CONDITIONS OF APPROVAL:

Engineering - PUD Plan Checklist

39. Labels

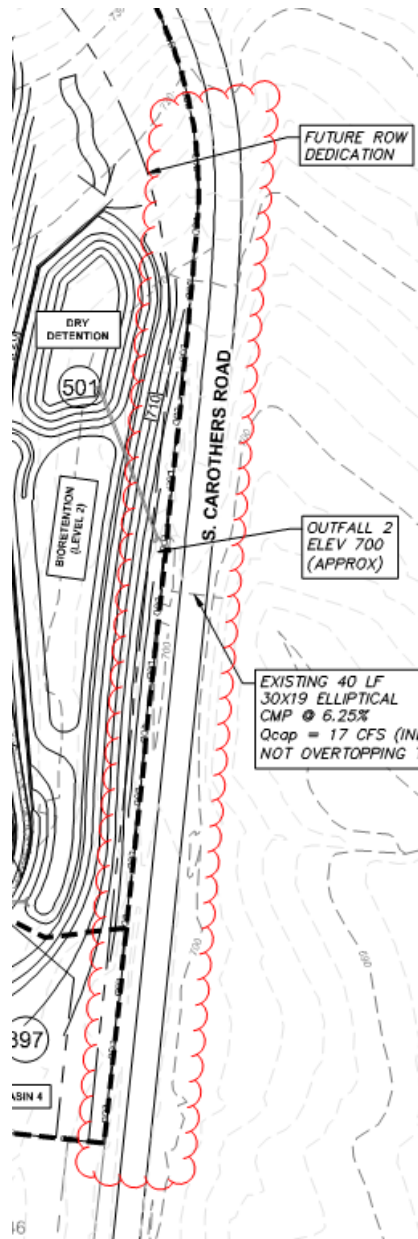
Applicant to clarify the 4 lines highlighted below with labels. Currently, only the LOD line appears to be labeled.
